- A. 15.041 77 Excelsior Mixed-Use Development
77 Excelsior Ave, Site plan review for mixed-use development with 90 multi-family residential units and 1,440 sq ft of commercial space in the Transect-5 Neighborhood Center (T-5) District.
Documents: 15.041 77EXCELSIORMIXEDUSE_APP_REDACTED.PDF, LA GROUP RESPONSE TO PLANNING COMMENTS 11.4.15.PDF, PLANS UPDATED 11-4-15.PDF, WATER SERVICE CONNECTION AGREEMENT.PDF
- B. 16.015 West Ave Mixed-Use
106-120 West Ave, Sketch site plan review for mixed-use development of 36 residential units and 4,100sf of commercial within the T-5 District.

1. Project Name: 77 Excelsior Mixed Use Development

Kate Maynard, AICP
Principal Planner
City of Saratoga Springs
474 Broadway
Saratoga Springs, NY 12866
kate.maynard@saratoga-springs.org

77 Excelsior Avenue Mixed Use Development

2 STAIRS & RAMP ENLARGEMENT
 SCALE: NTS
 1 inch = 10 feet

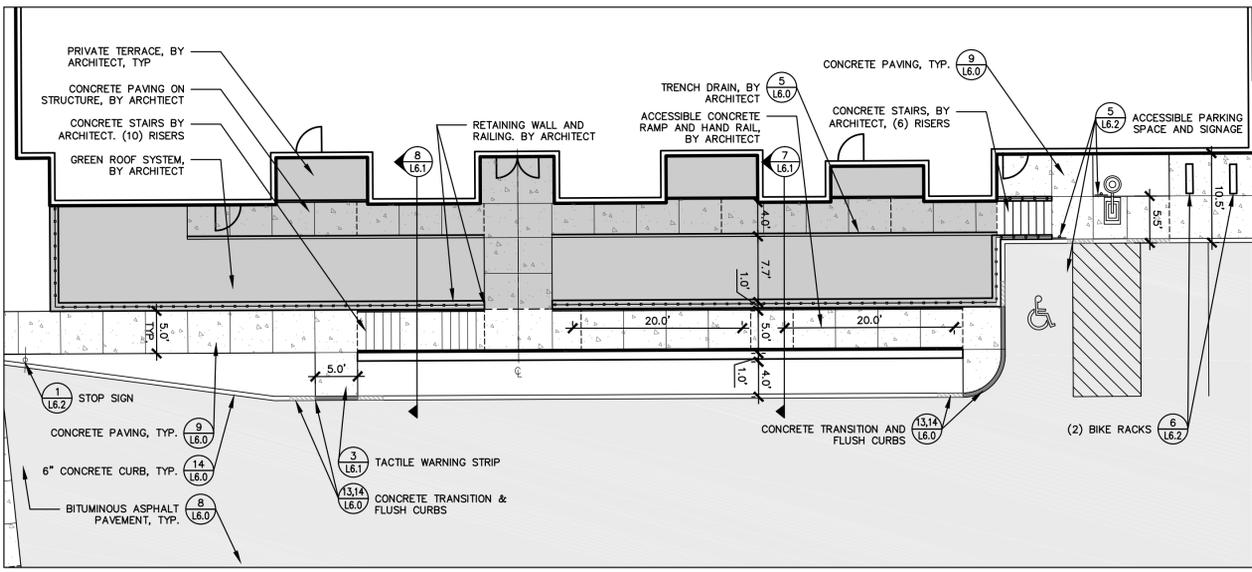
Comment: Access ramp- is there enough clearance to turn wheelchair on ramp?

Response: Access ramp has been revised due to building changes. Access ramp meets ADA guidelines.

Drawing No.
L-2.0

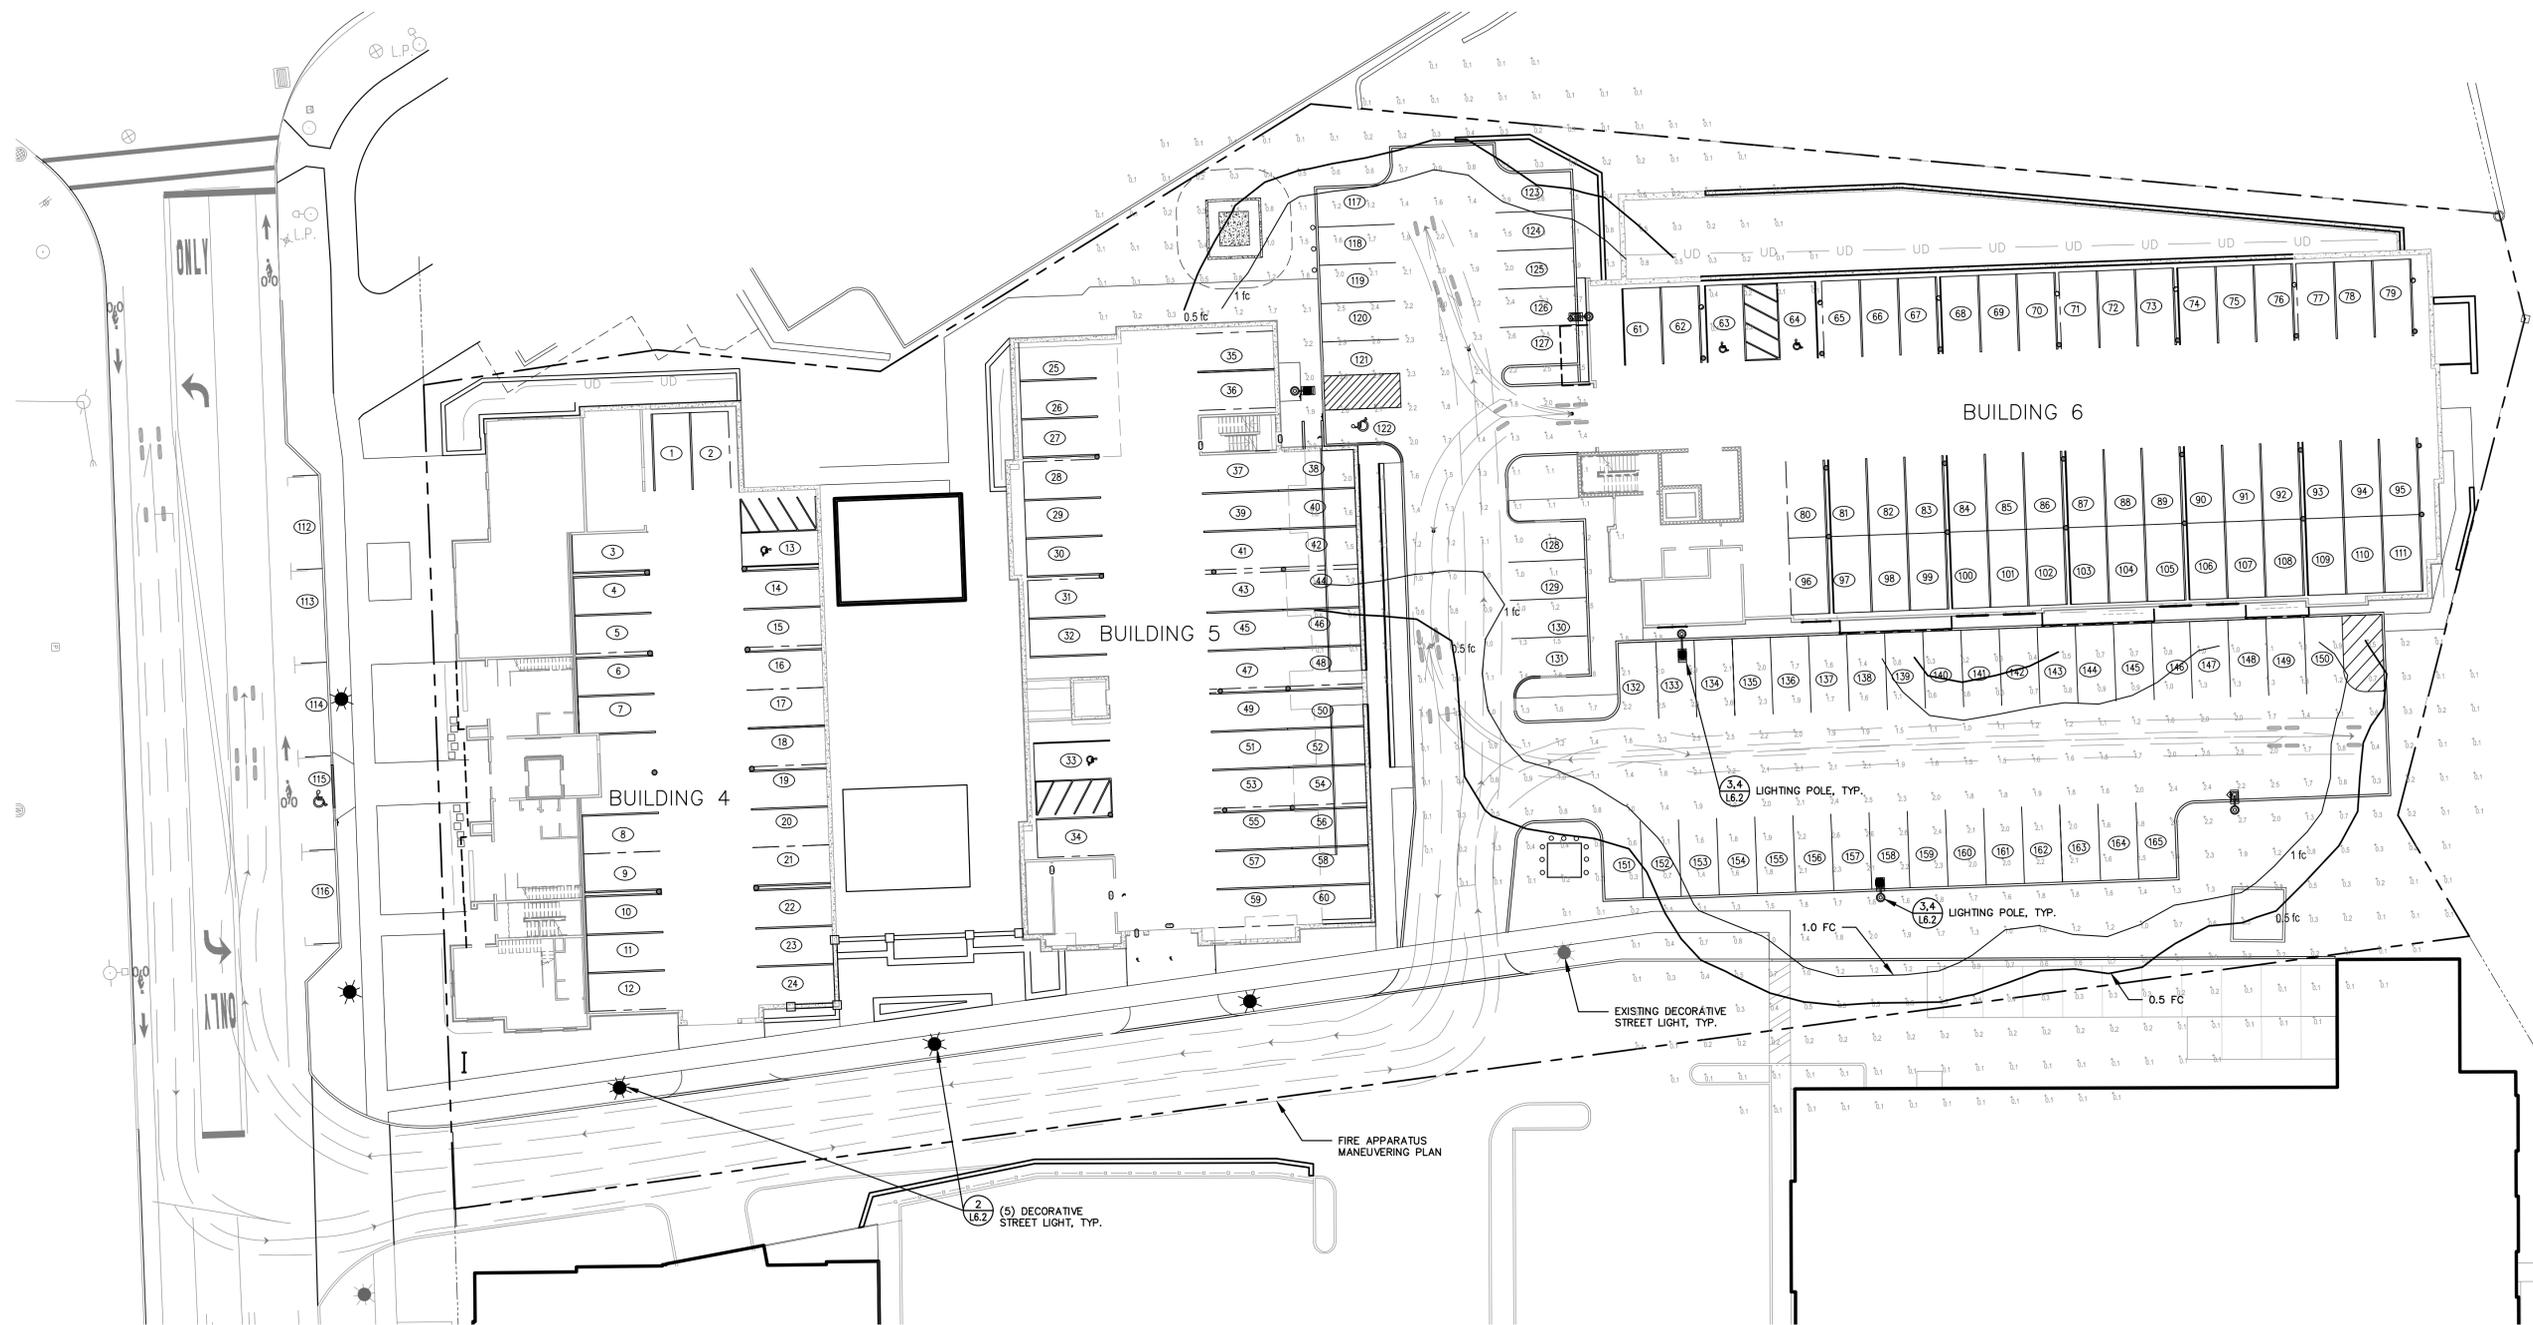
Comment: Walk in office portion of 3 live/work units – present at grade. Note should be added to plans that require ground level space to remain commercial.

Comment: Bike lanes need to be shown on plan.

Response: **A note has been added to Layout & Materials Plan indicating ground level spaces shall remain commercial.**

Response: Bike lanes are depicted on Sheet L-2.0, Layout & Materials Plan.

9 COURTYARD SECTION
SCALE: NTS

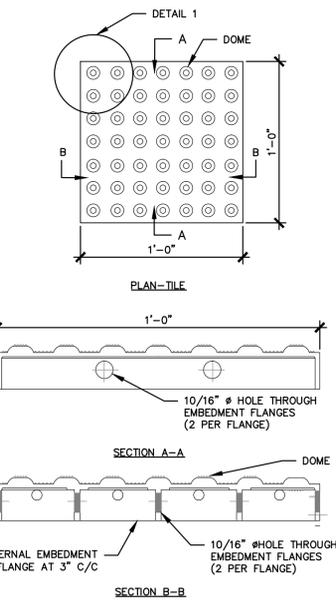
Comment: Courtyard- water feature wall still has height of over 12', ability to break down wall through materials, articulation, potentially a clear fence at top? Bench placement from illustration needs to be clarified.

Response: A fence is proposed on either side of the water feature. A rendering will be shown at the Planning Board meeting of this wall. The seat wall will be used for seating.
